Plot F, Great Jackson Street – Manchester

TOWER F1 & F2 - VISUAL MOCK-UP SUMMARY | SEP 2024
10334-Z1-SHP-A180-Rp-XX-VMU01 | REVISION P 01

Visual Mock-Up (VMU) summary

Dwg title: DRAINAGE STRATEGY MAIN FACADE

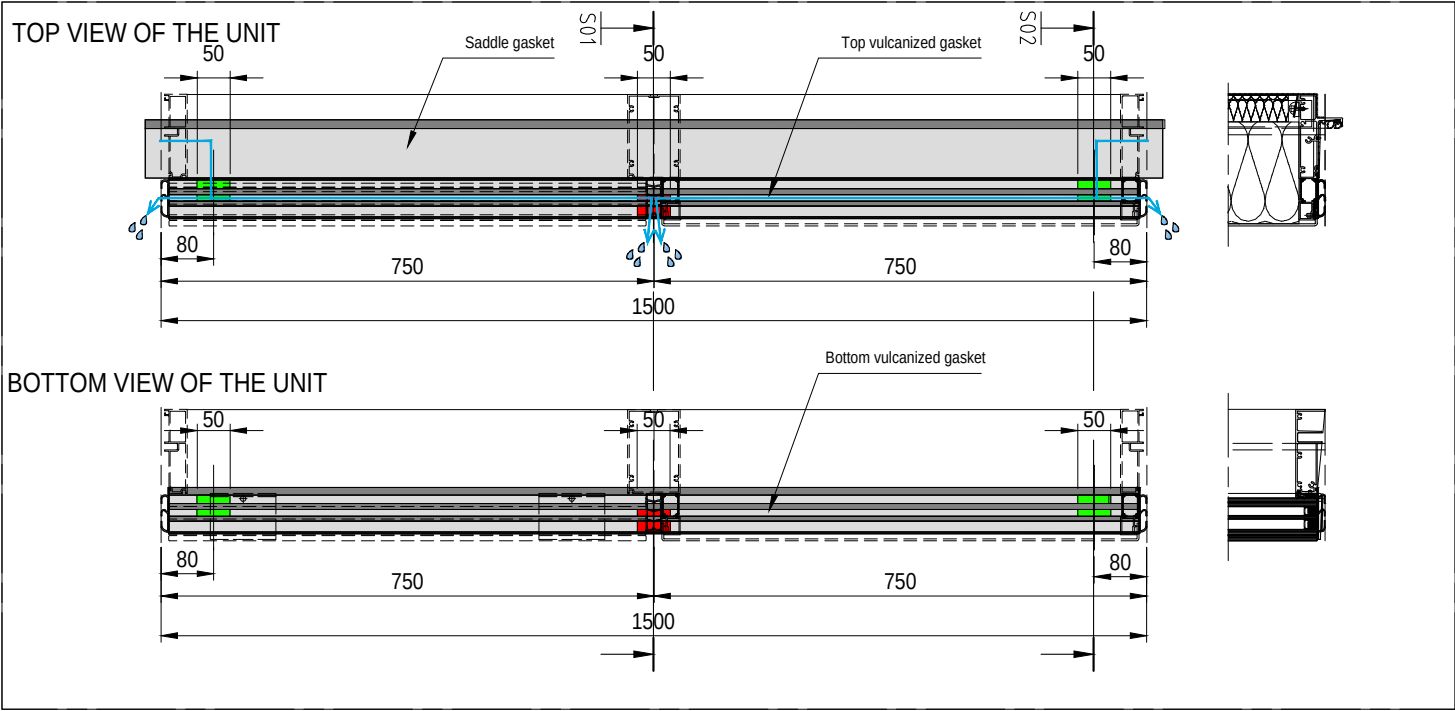
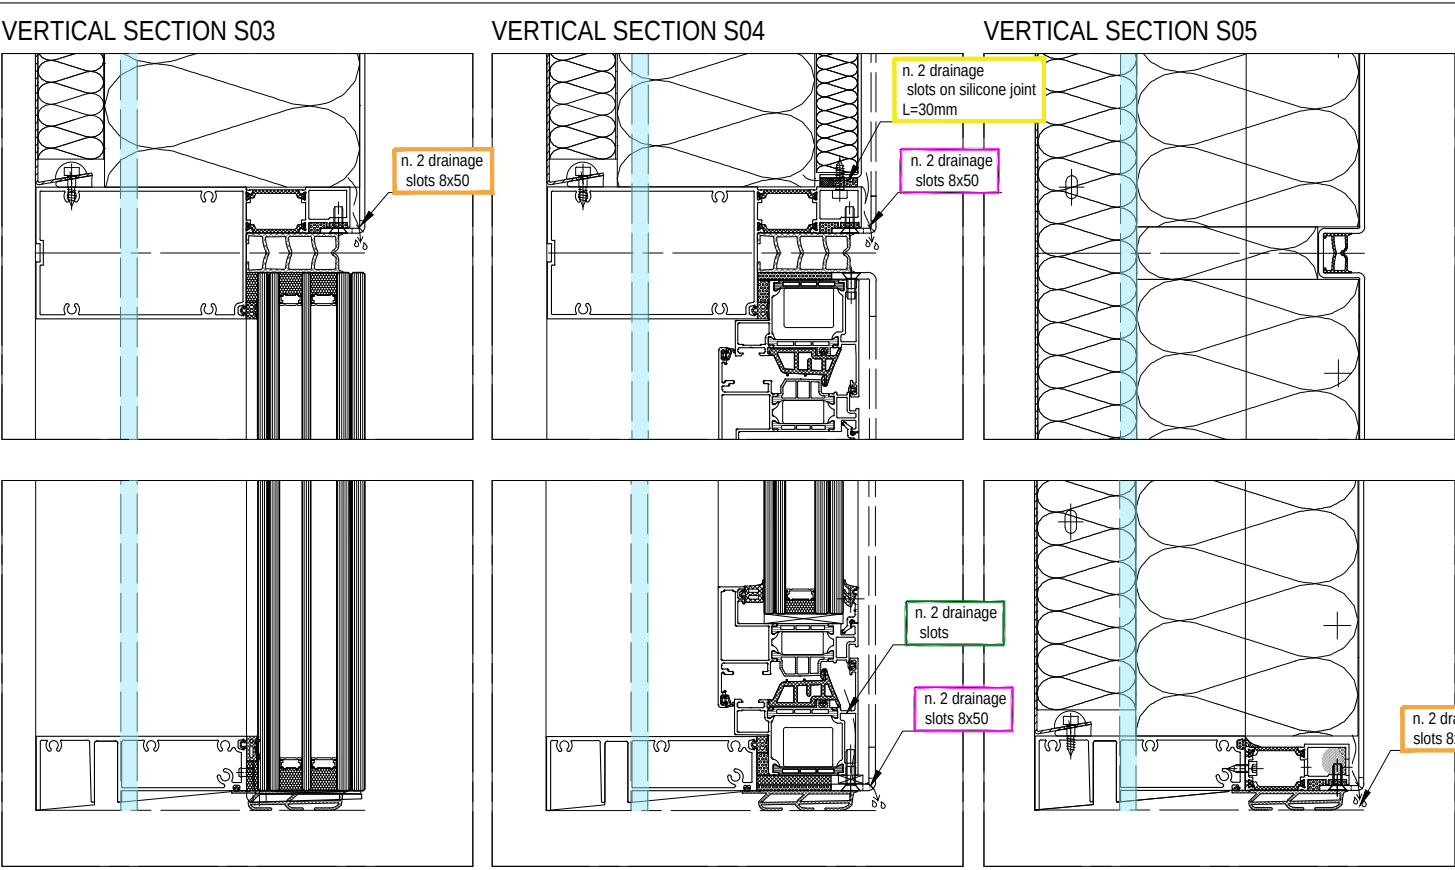
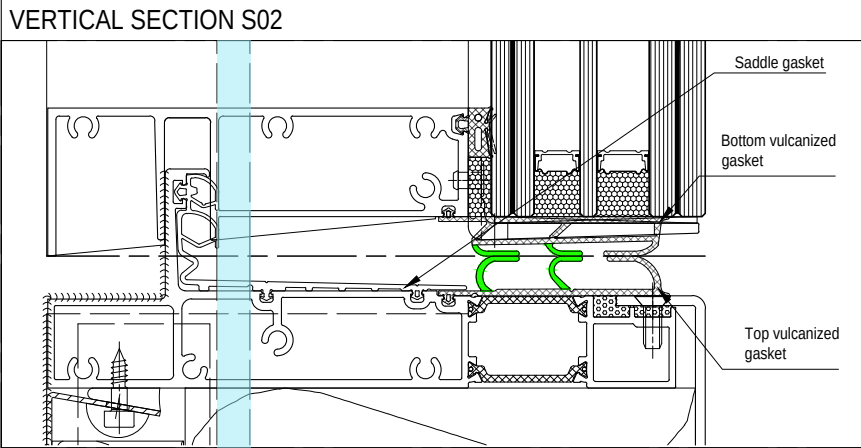
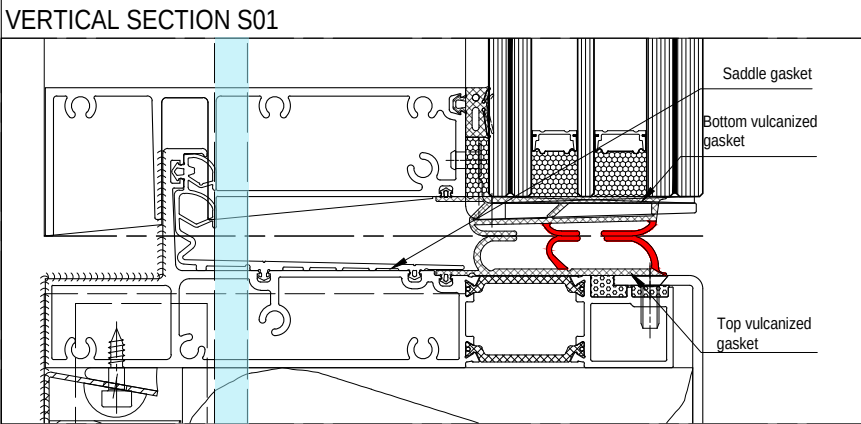
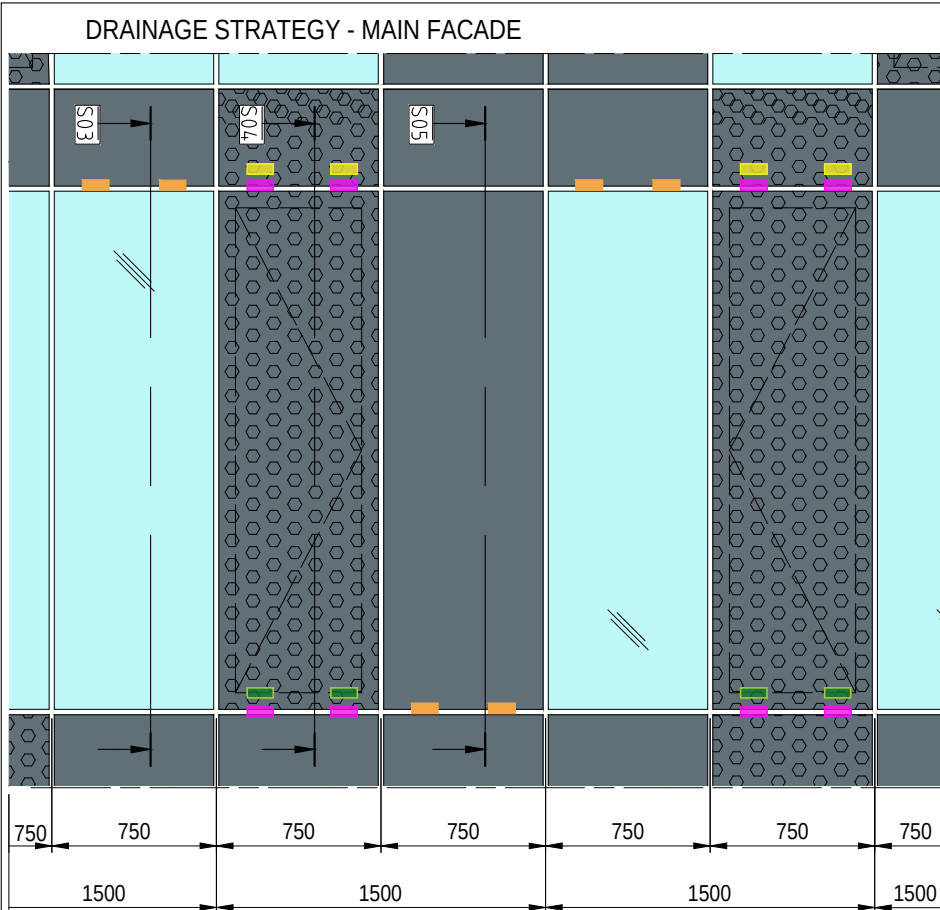
MCC queried the scale of the drainage slots present on each of the solid panels, the rationale for the size and quantum of the slots is covered in further detail in the following pages with a technical note provided by Focchi.

MCC comments
MCC queried the requirement for the size and quantum of the drainage slots present in the solid panels.

SH comments
The slots are of the same dimensions used across Deansgate Square, Crown Street Phase 2 (The Blade and Three60) appearing on the perforated purge vent sheets to allow rainwater to drain from the back of the panels. Tower F1 and F2 do not feature any back painted glass units there are therefore comparatively more metal sheets to incorporate the slots than other schemes in the New Jackson area.

On document Z1-FOC-G251-RP-XX-004 we have clarified the drainage strategy for the unitised system of this project, where on the external metal panels we have introduced No.2 slotted holes at the bottom on each panel (if wider than 500mm) and No.1 slotted hole if wider less than 500mm in order to allow a proper path to drain the water out.

In relation to the type of facade we are talking about (high-rise buildings), where external accessibility of the building sets limits for the control and cleaning of drainage slots, it's therefore necessary to increase the size of the drains, also in view of the high pressures to which the panel is subjected. Based on our experience that Manchester we know that it's one of the most severe area in relation to water quantities and wind pressures.

The TN17 recommend 25x5mm drainage slote as a minimum for the standard buildings with the typical hight but from our experience we know that this dimension causes the surface tension of adhesion of the water film on the aluminum surfaces and for this reason is necessary to double this minimum.

For high rise buildings, pressure and amount of water certainly play against it, and the proposed size 50x8mm incorporate a safety factor to avoid any kind of occlusion.

Pointing Options Reviewed

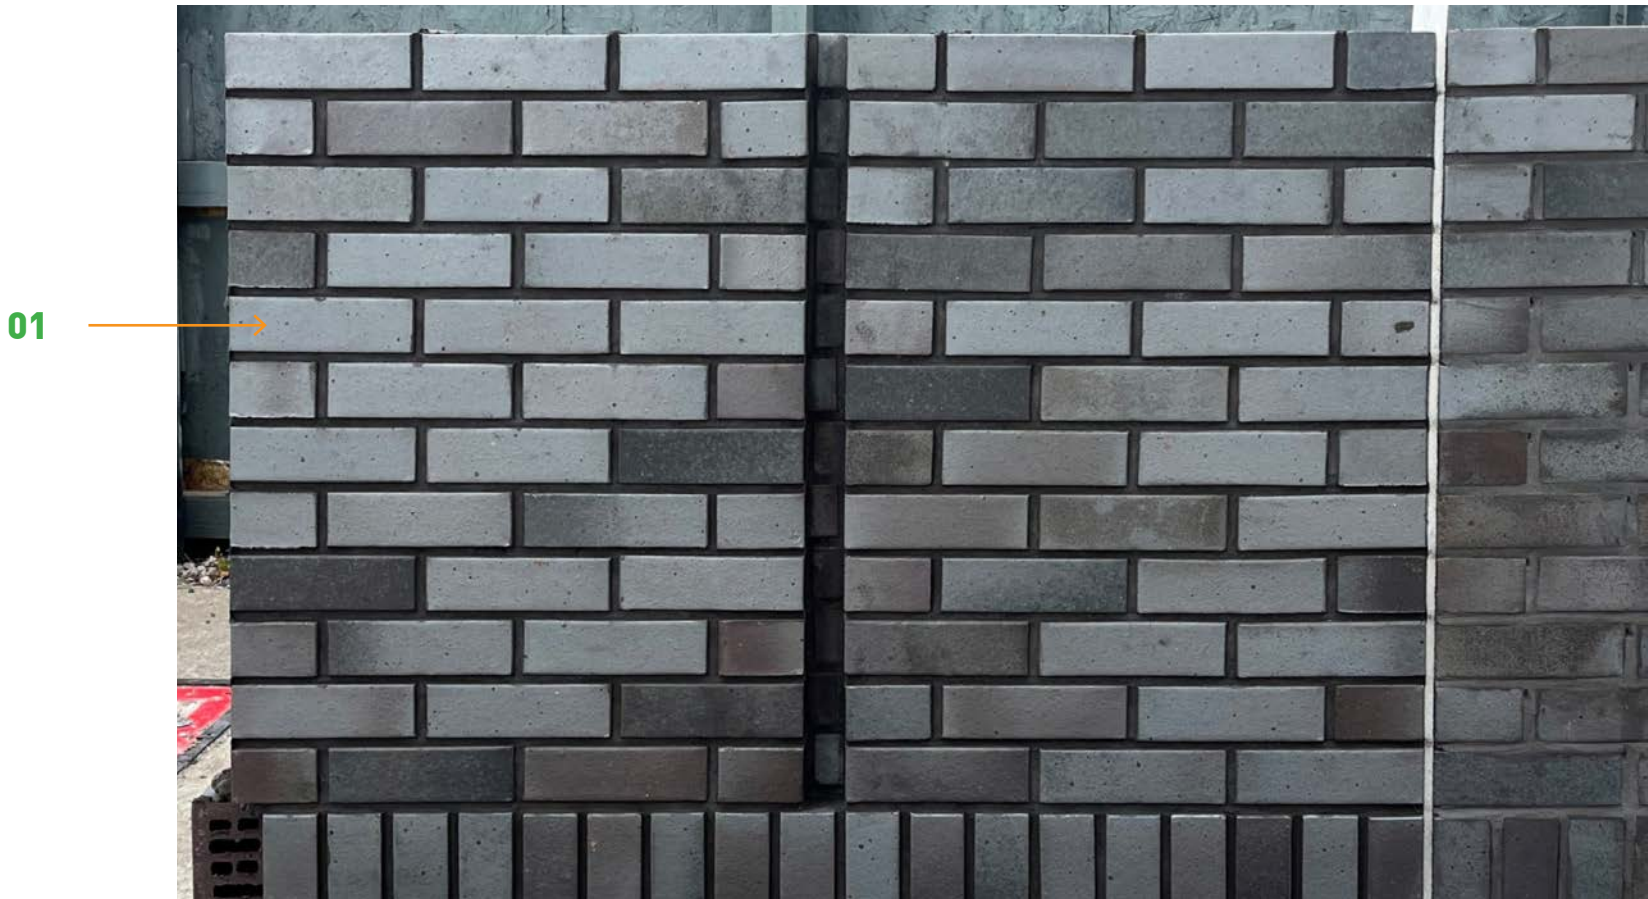
On the same date and time as the tower visual mock-up, the sample panel for the brickwork was also presented to MCC. In total three sample panels were reviewed, two of which (top right) showed the options that had been reviewed by the design team with regard to mortar colour and pointing options.

The third and final panel (bottom right) shows the design team’s chosen configuration of brick, mortar and pointing. MCC were in agreement that the final panel demonstrated the strongest configuration.
